Commonwealth Edison
One First National Plaza, Chicago, Illinois
Address Reply to: Post Office Box 767
Chicago, Illinois 60690

Subject: Dresden Station Units 2 and 3
Quad-Cities Station Units 1 and 2
NRC Docket Nos. 50-237, 50-249,
50-254, and 50-265

The following is in response to your August 23, 1976 letter requesting additional information in regard to long term cooling capability relative to Dresden Station Units 2 and 3 and Quad-Cities Station Units 1 and 2.

Response to NRC Questions Concerning LPCI/RHR
Pump Runout Situations

FIGURE 5.2.15. CONTAINMENT PRESSURE RESPONSE FOLLOWING DESIGN BASIS LOSS OF COOLANT ACCIDENT

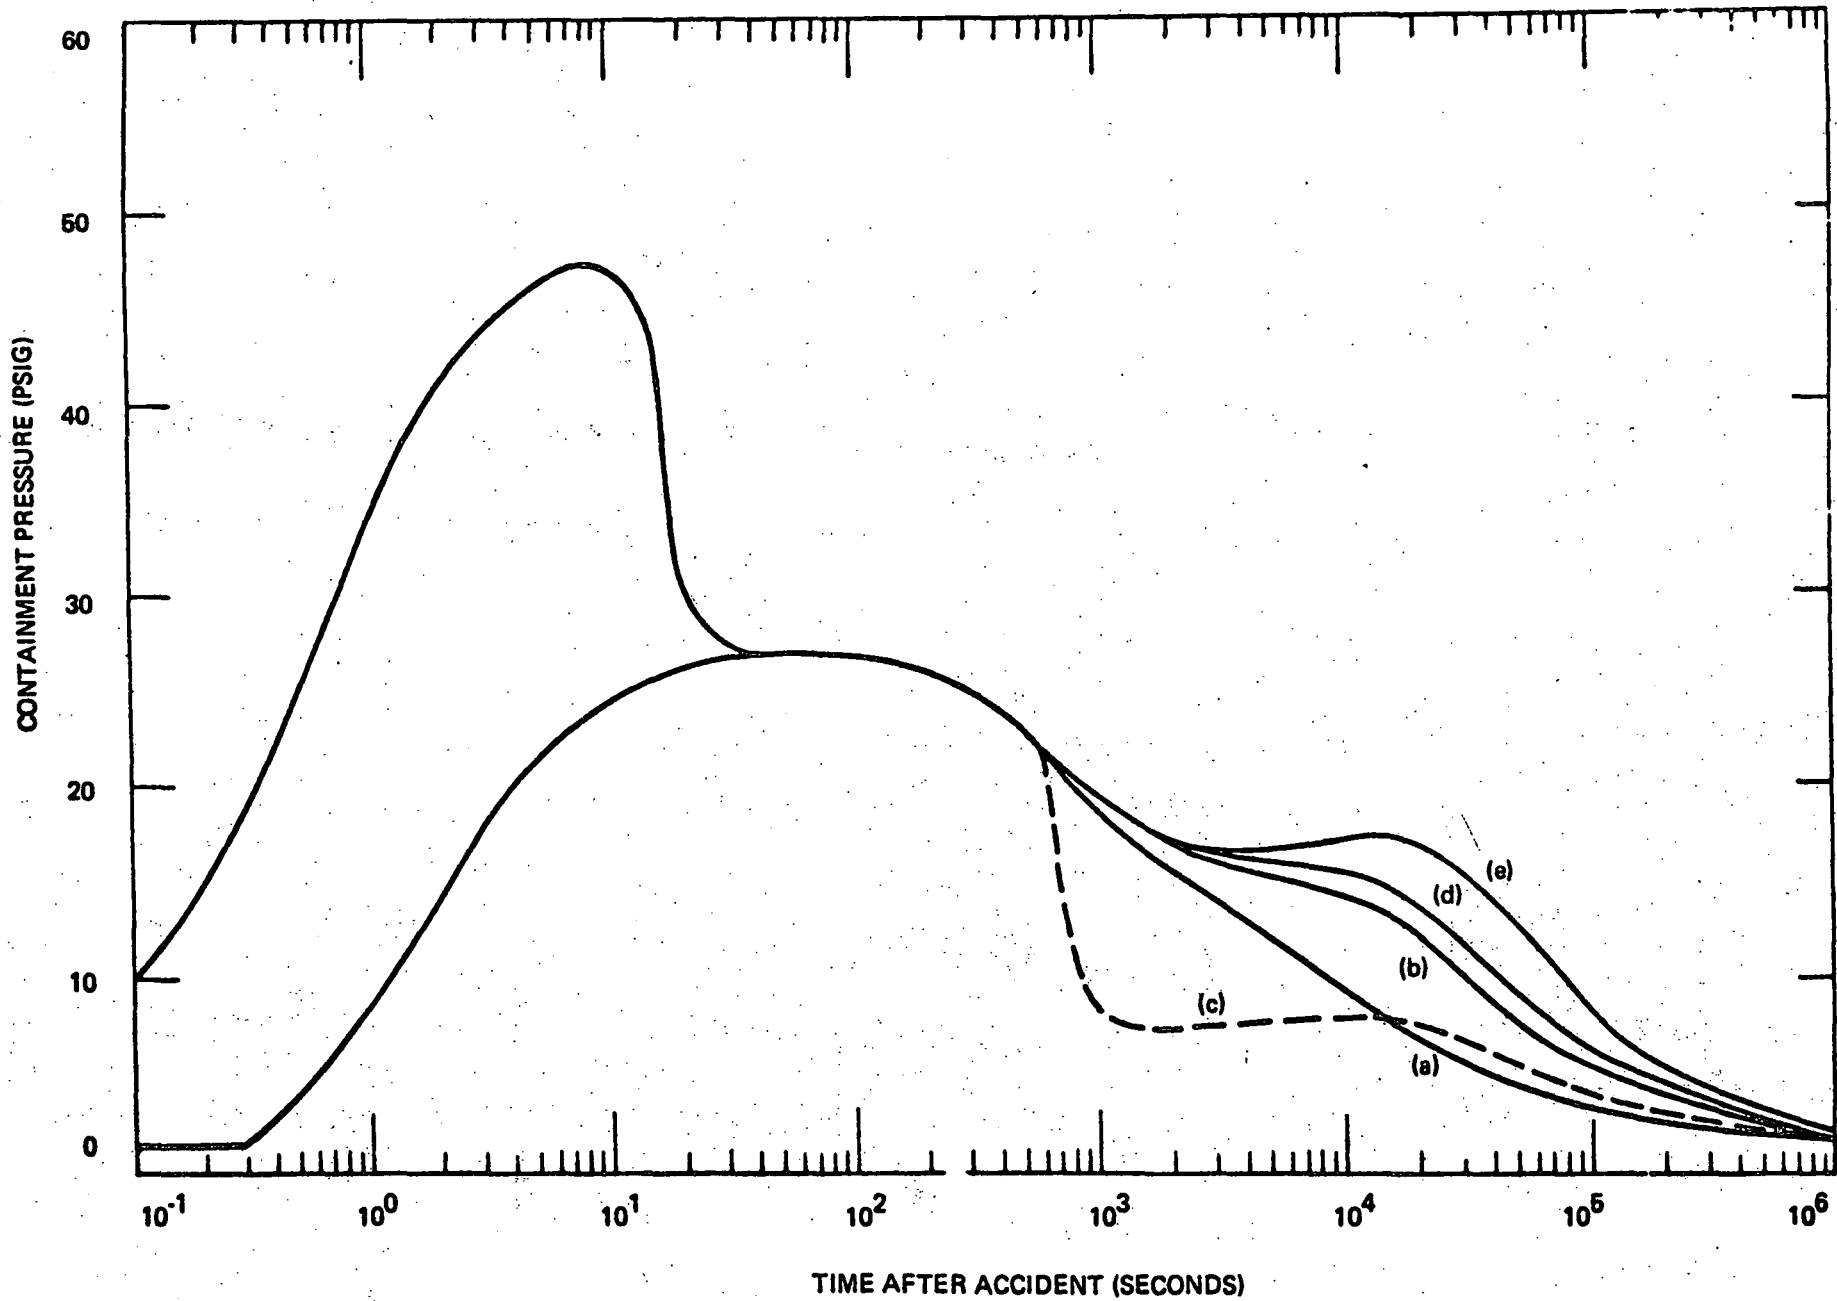
Question 2: For the case resulting in largest RNPSH minus ANPSH, describe the NPSH available as a function of time, both short-term and long-term, in the event of a postulated loss-of-coolant accident. Suppression pool temperatures versus time should be indicated, and the effect of pool temperature should be included in the calculation.

The suppression pool temperature versus time for a postulated LOCA is illustrated by the attached figure 5.2.17 from the Quad Cities FSAR. Also attached is the corresponding containment pressure plot. These figures show that, while torus temperature reaches 130°F within about 2 minutes, containment pressure in a similar time period approaches 25 psig. The suppression pool temperature increase from 95°F causes mild decrease in available NPSH for suction on the torus due to the increased vapor pressure of the pool water. However, the associated pressure increase easily compensates for the temperature induced deficiency. Incorporating both the temperature and pressure effects in the NPSH calculations (this should not be in violation of appropriate Regulatory Guides, since credit for the pressure increase is not required to provide adequate cooling flow.) yields an available NPSH at equilibrium of about 91ft for the worst case (RNPSH for this case is 40ft). Consequently, adequate NPSH is available in even the worst case analyzed to insure that no danger to the pumps will occur.
